INSTRUCTION TO SERVICE

ITS: 59166		10-Feb-2021
SECTION:	219-Engine and Transmission	
WRITTEN BY:	Mike Pearson	
SUBJECT:	Inspect and replace BAE ISG mounting bolts	
ISSUE:	Existing ISG mounting bolts may be loose due to initial incorrect torque.	
SUMMARY:	ISG mounting bolts need to be replaced and installed with correct torque

Figure 1: HV Cable Support Bracket Mounting Bolt Locations

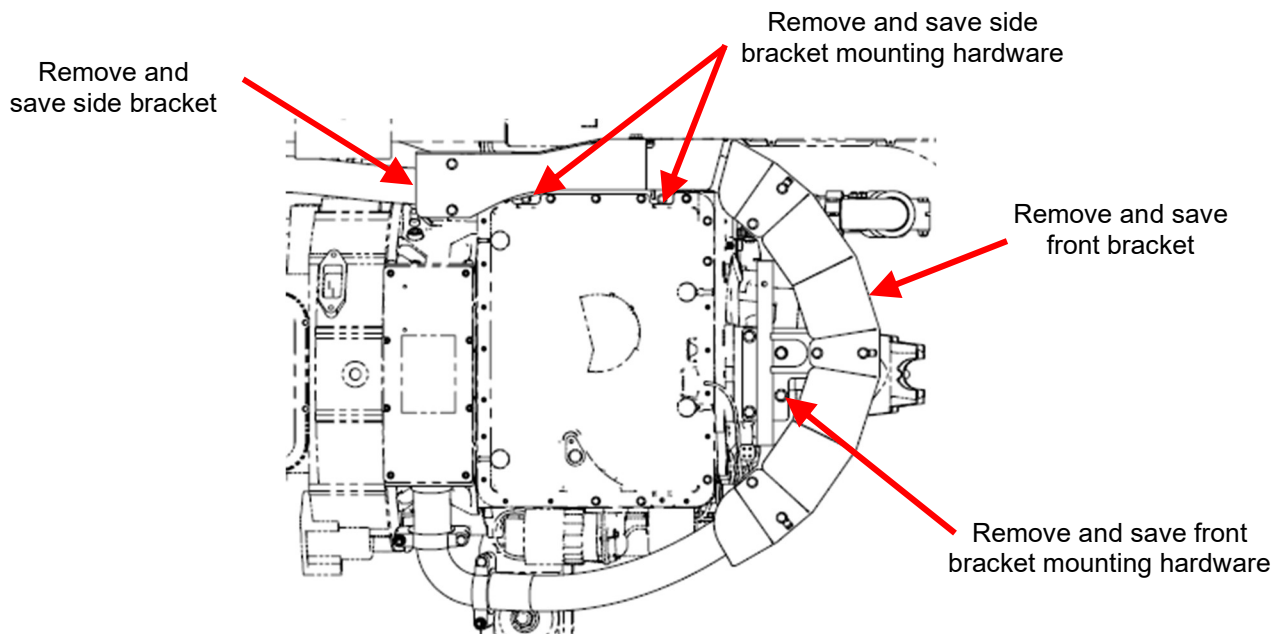
1. Set park brake and chock wheels.
2. Turn the main battery disconnect switch to the "OFF" position and lock out.
3. If necessary, raise coach in accordance with the New Flyer Service Manual.
4. Removal of the HV cable brackets may be required, this will allow room to access the ISG mounting bolts number 10 and 5, see Figure 1 for bracket bolt locations.

10. Repeat for the 9 remaining ISG mounting bolts, removing one bolt at a time in a star pattern.
11. Reinstall the side bracket if removed in Step 4, in the same location and orientation as removed and torque existing hardware to 5 to 7 ft lb.
12. Reinstall the front bracket if removed in Step 4, in the same location and orientation as removed and torque existing hardware and torque to 44 +/- 4-ft lb.
13. If necessary, lower coach in accordance with the New Flyer Service Manual.
14. Remove lock out and switch the bus on, then return the bus to service.

Figure 2: BAE ISG Mounting Bolt Locations

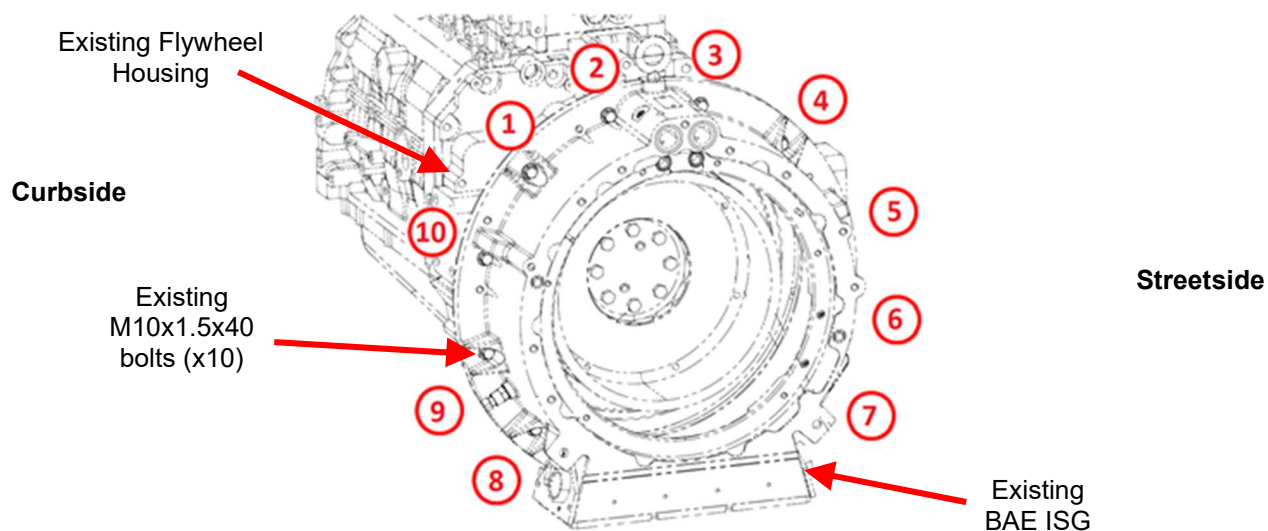
5. Locate the BAE ISG mounting bolts as shown in Figure 2.

⚠ WARNING: If **ALL 10** bolts have torque stripes and **ALL 10** torque stripes are aligned, continue to the next Step. If **ANY** bolt is broken or has a missing or broken torque stripe, hold the bus from service and **contact your New Flyer RPSM for further instructions.**

6. Remove one bolt at a time in a star pattern.
7. Use a thread chaser to clean the threads in the bellhousing, then use a blow gun to spray compressed air into the hole to clean the hole of any old Loctite or sealant.
8. Apply Loctite 243, p/n 081034 to the new bolt threads p/n 436616 and the internal threads of the mating holes in the flywheel housing and install.
9. Torque the new bolt to 54.6 +/- 5.5 lb-ft. and torque seal the bolt. See Figure 3 to show how the torque seal must be applied.
